AS Builts

VALHALLA HIGH SCHOOL CENTRAL PLANT EQUIPMENT UPGRADE

BOILER/CHILLER/COOLING TOWER REPLACEMENT: WORK INCLUDES REPLACEMENT OF EXISTING BOILER, CHILLER AND COOLING TOWER AND ADDITION OF SEPARATION WALL BETWEEN BOILER AND OTHER EQUIPMENT. ALL WORK SHALL BE WITHIN THE EXISTING CENTRAL PLANT STRUCTURE.

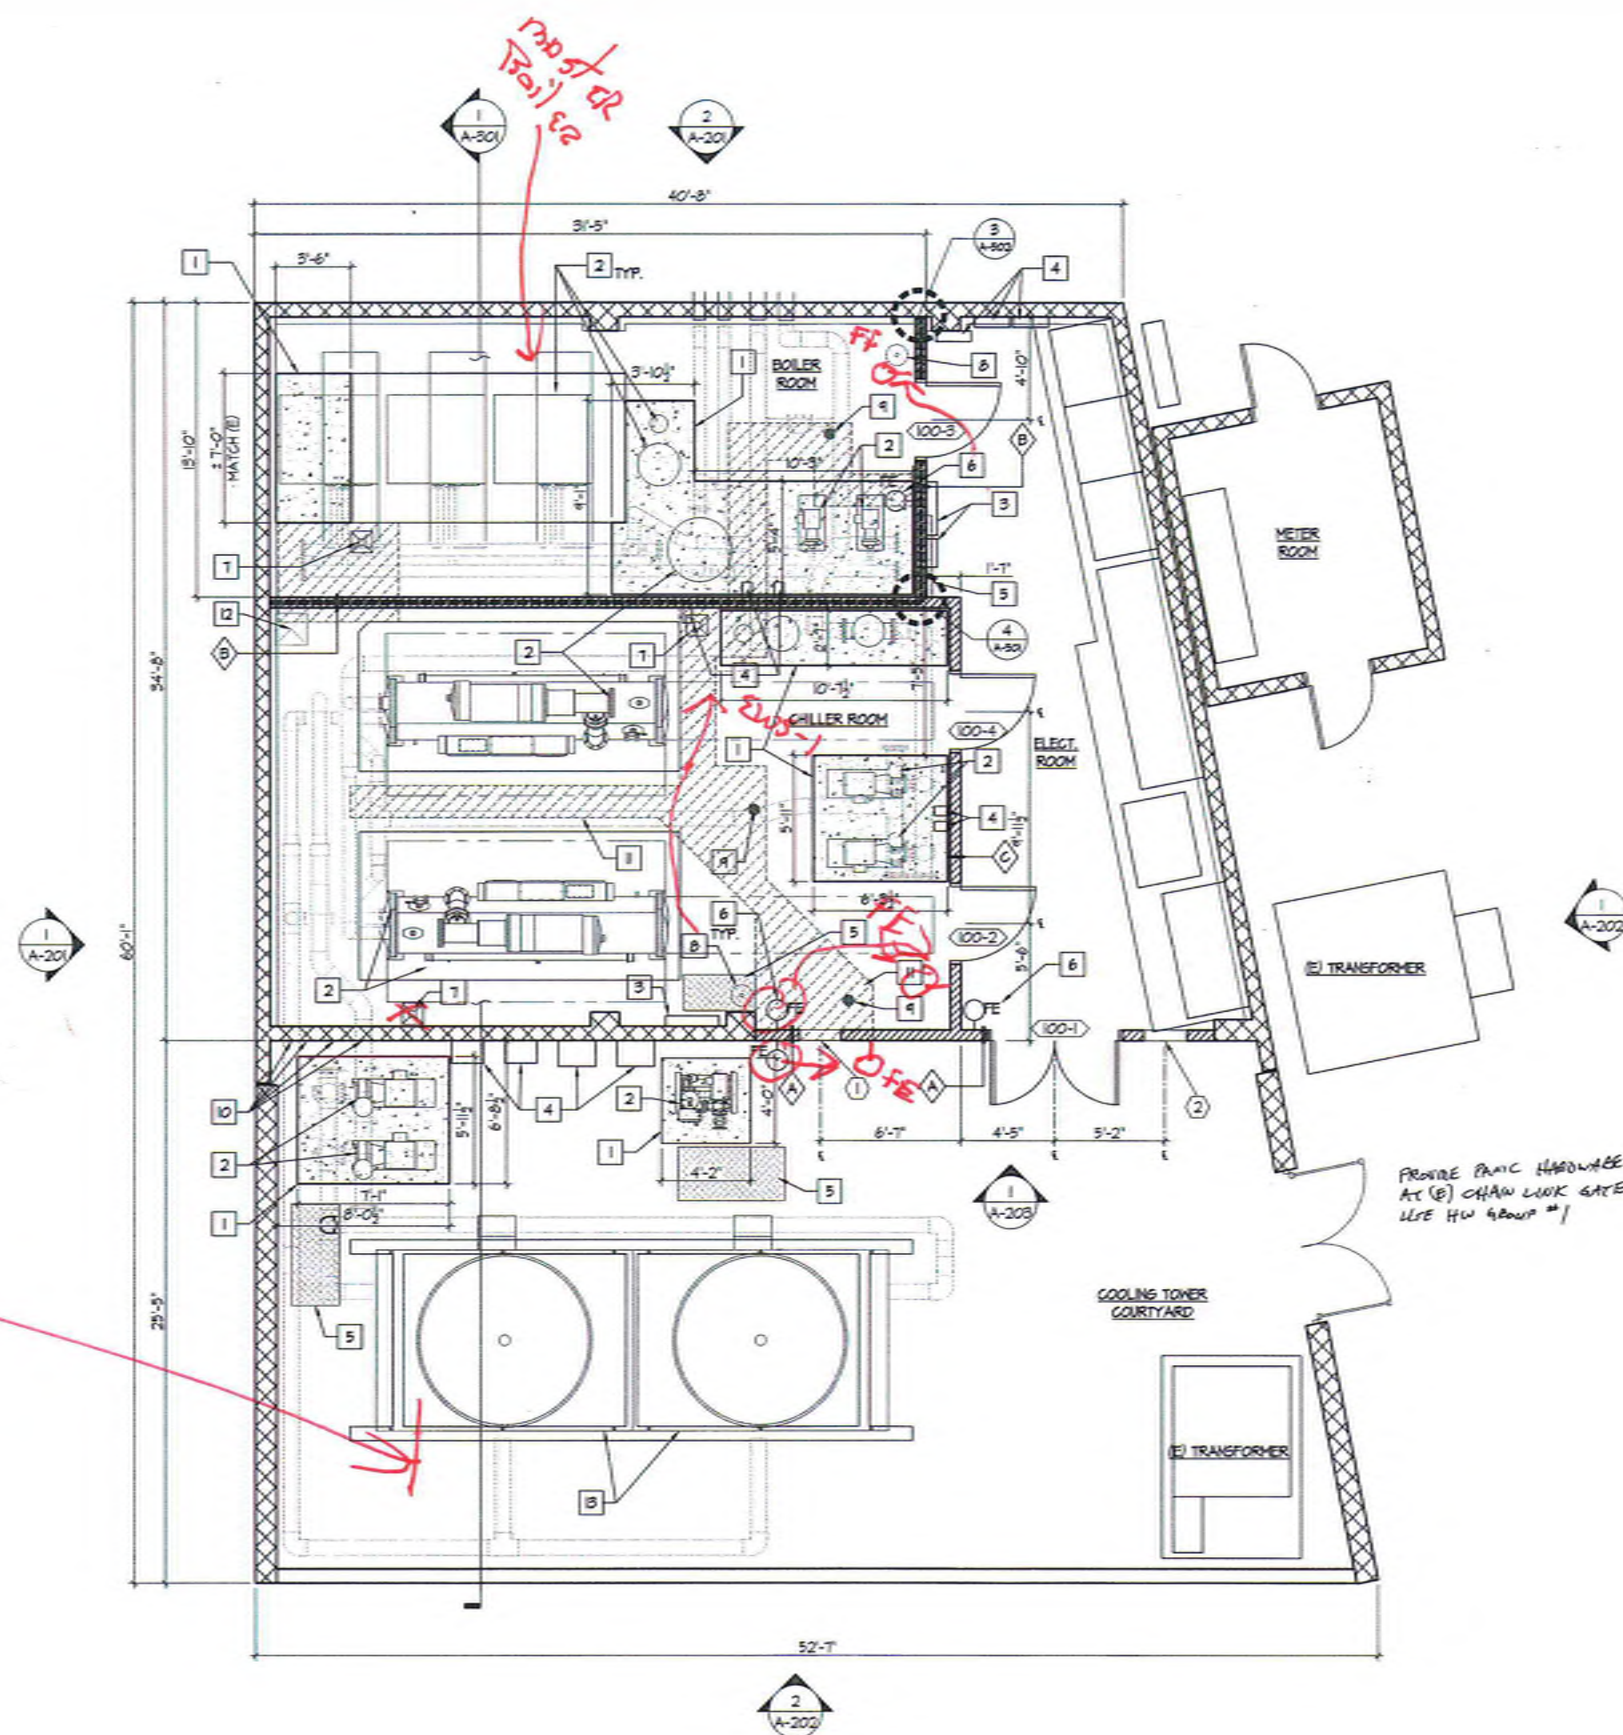
RFI #16
Steel beam
detail

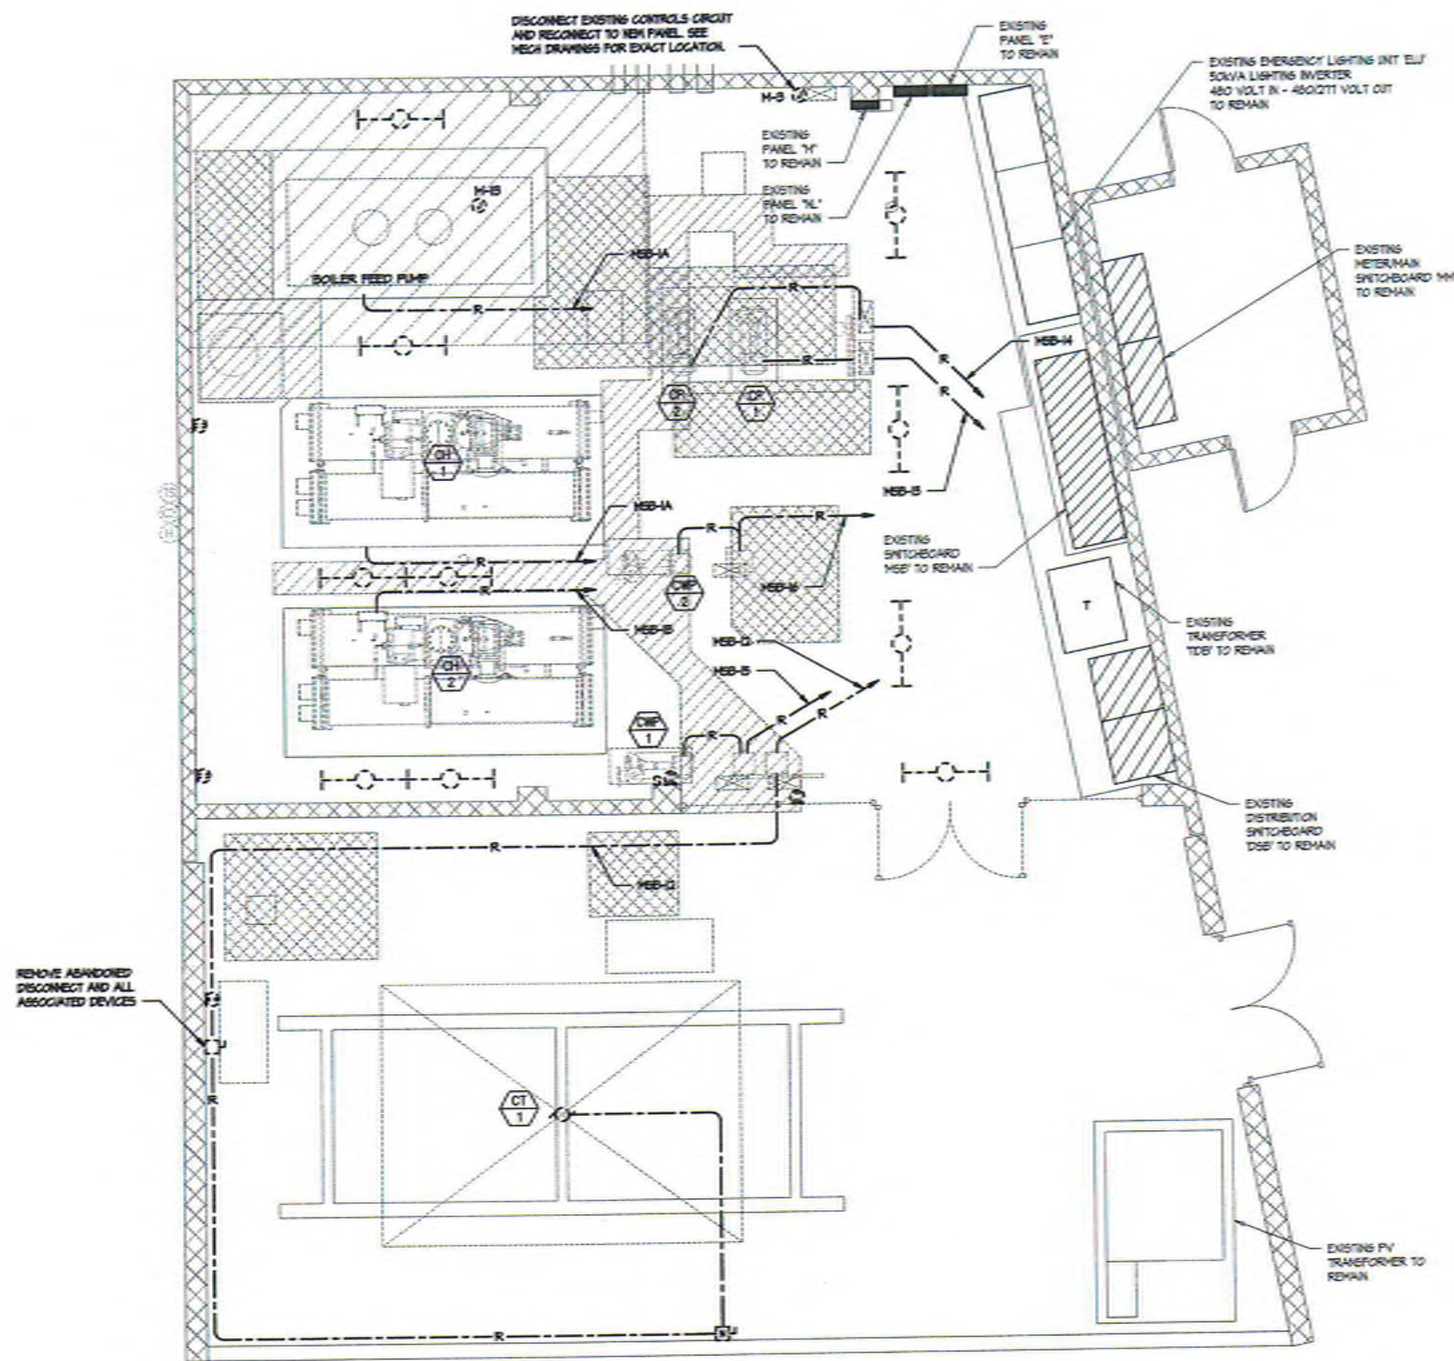
*all
lighting
mounted
@ ceiling*

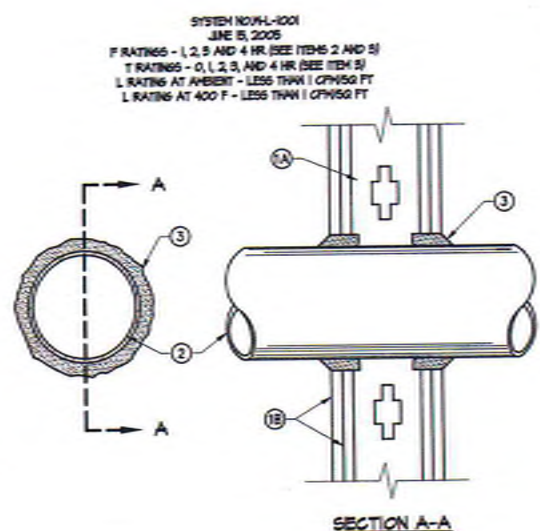
37 refrigerant Monitoring panel
